Cover Page 1142 Pittwater Road Collaroy NSW 2097 - Proposed Alterations & Additions

PROJECT
Proposed Alterations & Additions

DRAWING NUMBER
S4.55-00
ISSUE
C

NOMINATED REGISTERED ARCHITECT
GUS HONDA 9435
DRAWING TITLE
Elevations

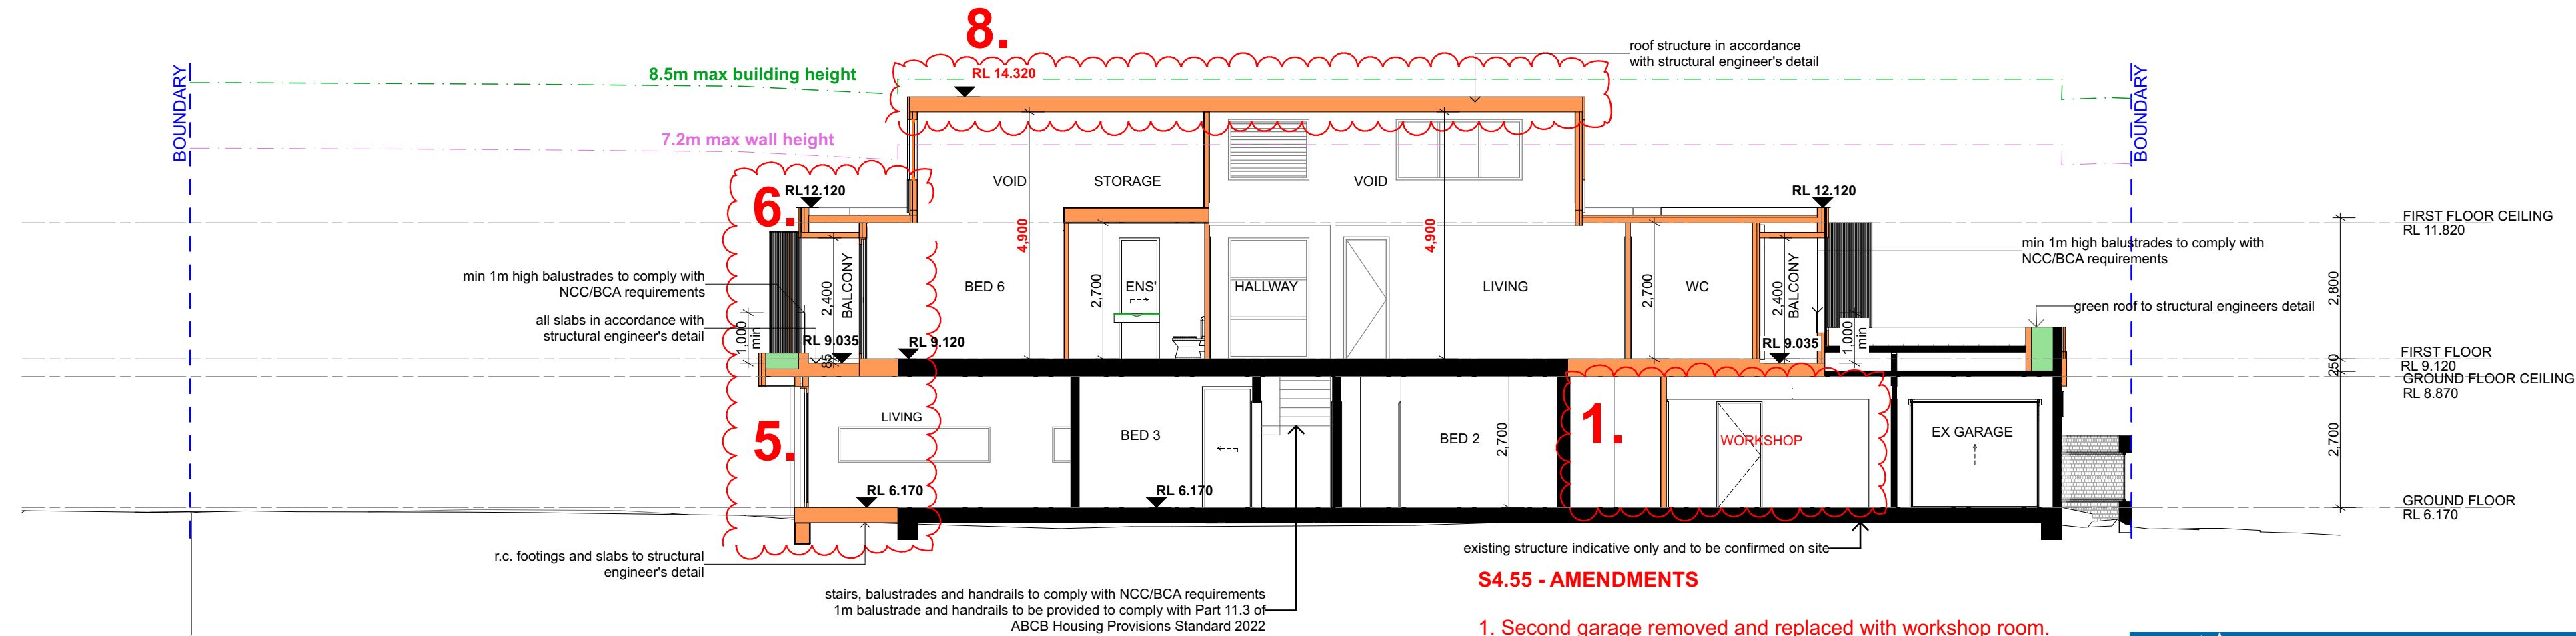
1. Second garage removed and replaced with workshop room. Garage door removed and access doors provided to the northern and southern walls.
2. Proposed retractable pergola.

3. Ground floor northern wall revised to align with the existing garage northern wall. Landscaped area amended accordingly.
4. Ground floor southern wall revised to align with the minimum ground floor side setback. Landscaped area amended accordingly.

5. Ground floor eastern wall revised to reduce building length and provide a more regular layout to the living areas.
6. First-floor southern wall, eastern wall, and roof planters adjusted to align with changes to the ground floor walls.

7. Proposed skylight over stairs.
8. Roof height slightly raised to provide additional ceiling space and natural light.
9. Windows and doors reconfigured in accordance with owner's requirements (refer to external window & door schedules).

Shadow Diagrams

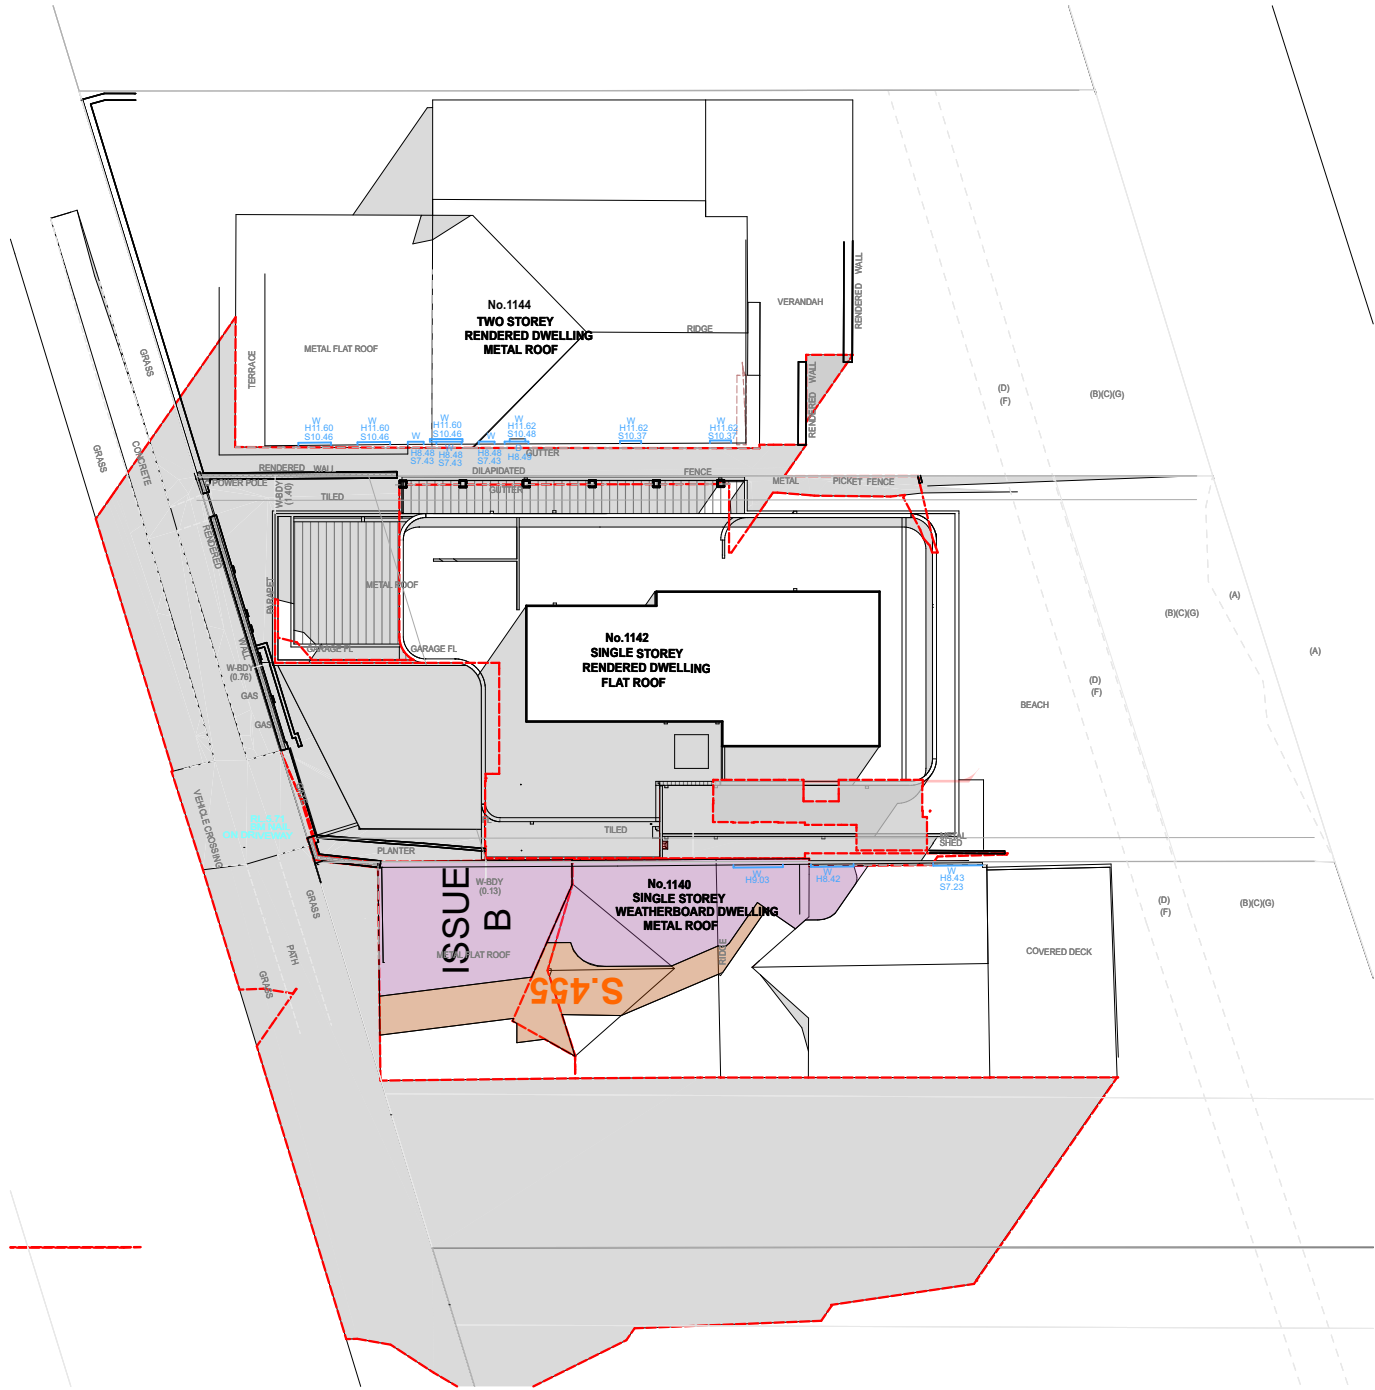
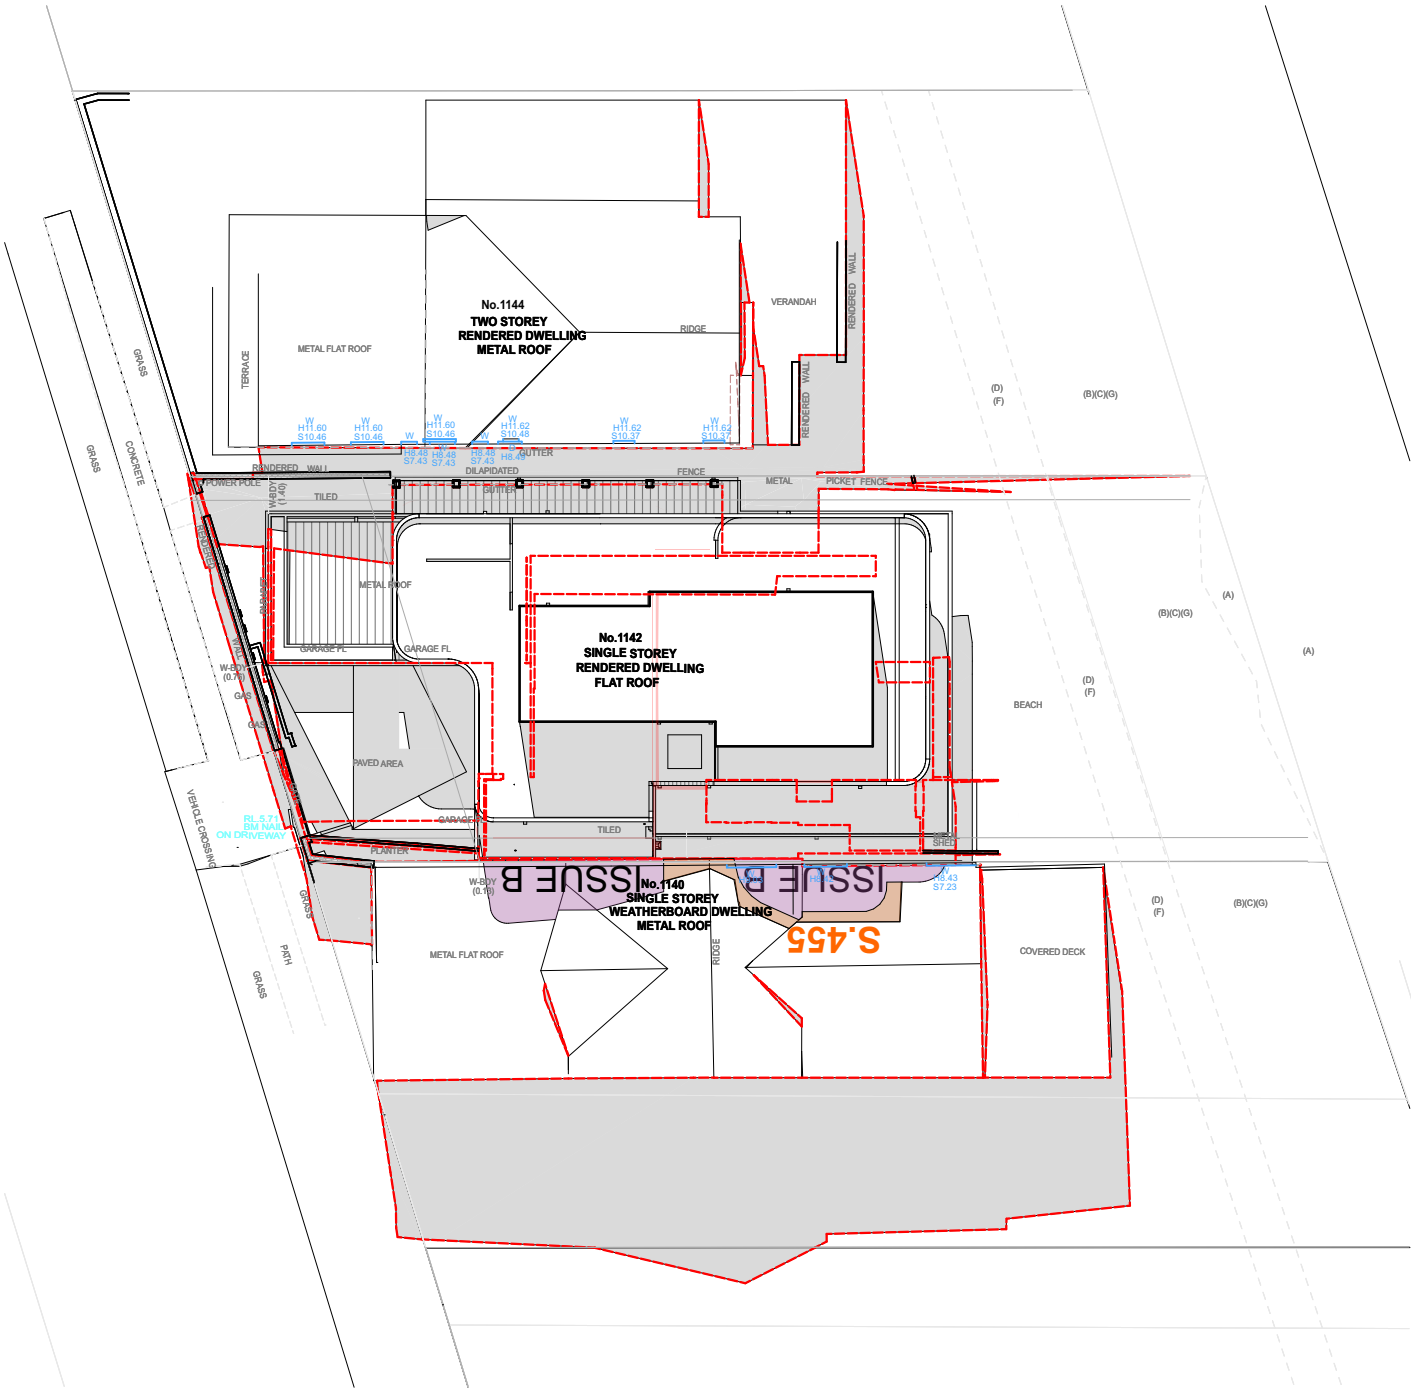
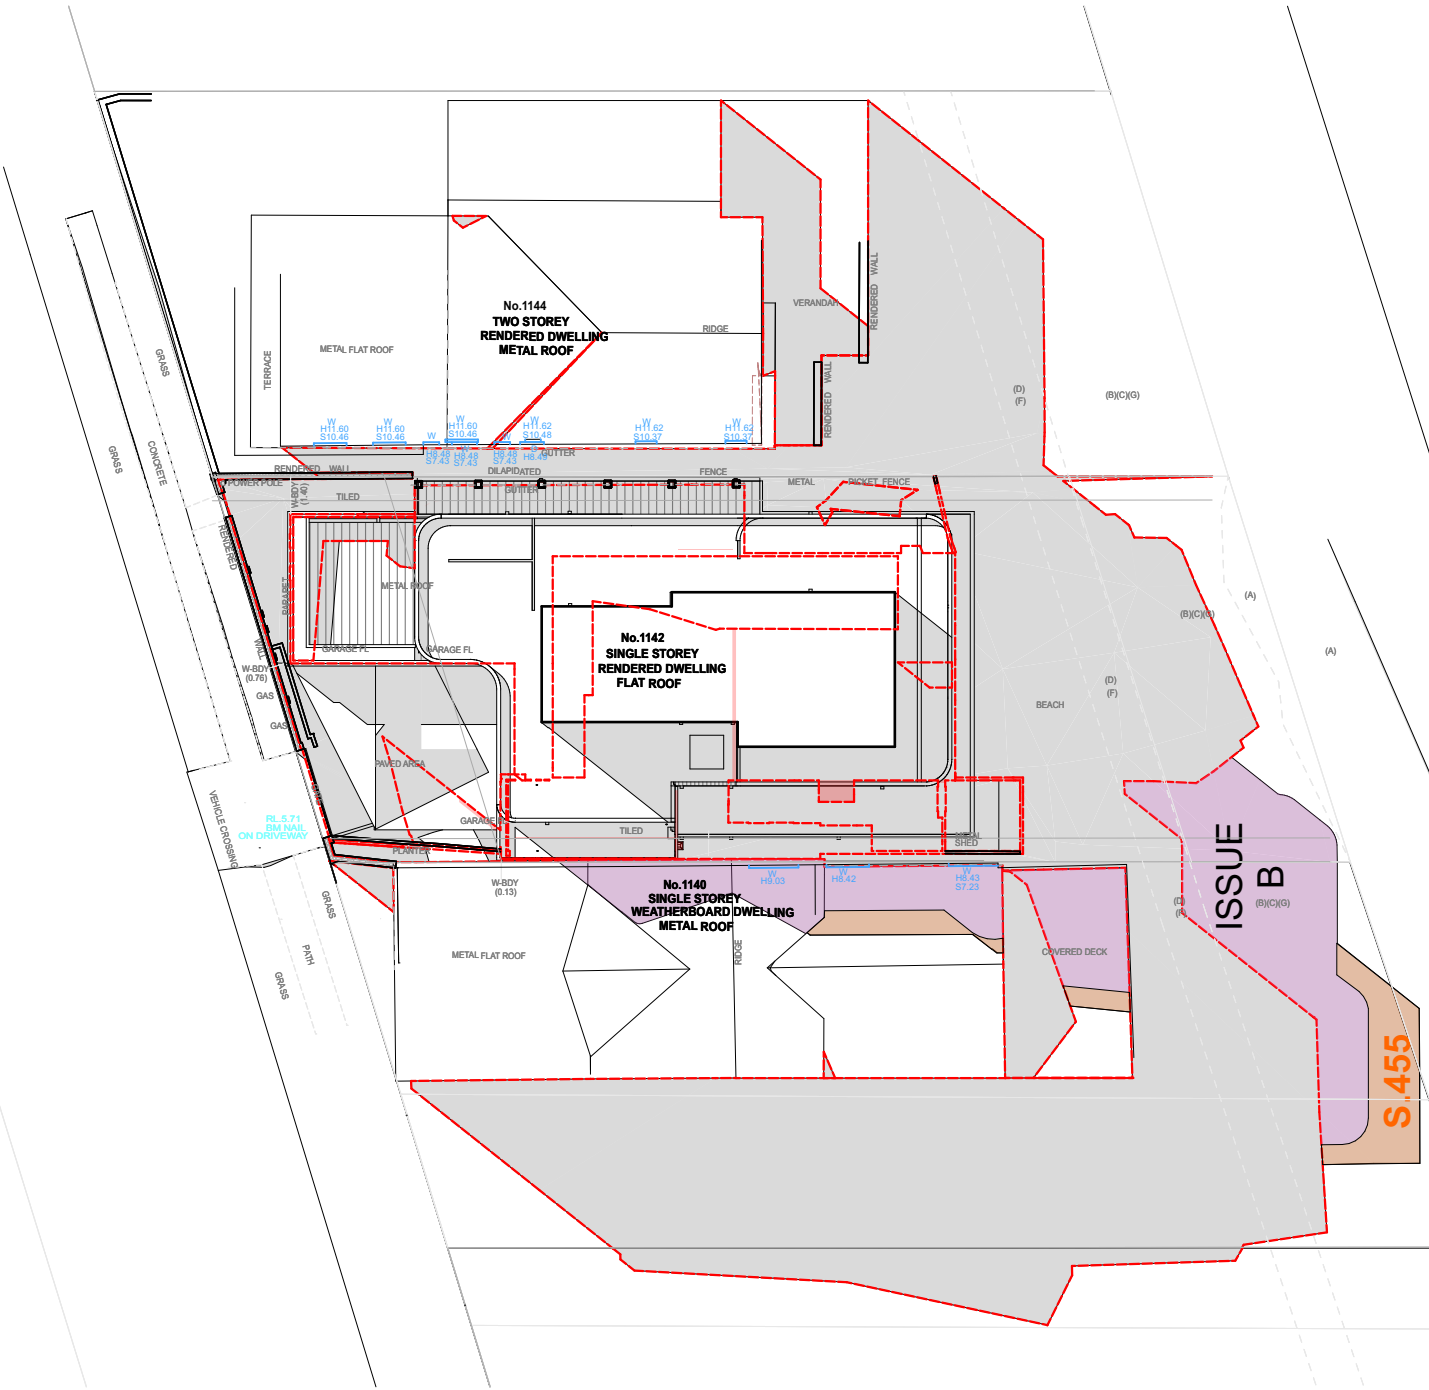
ISSUE B overshadowing

S4.55 overshadowing
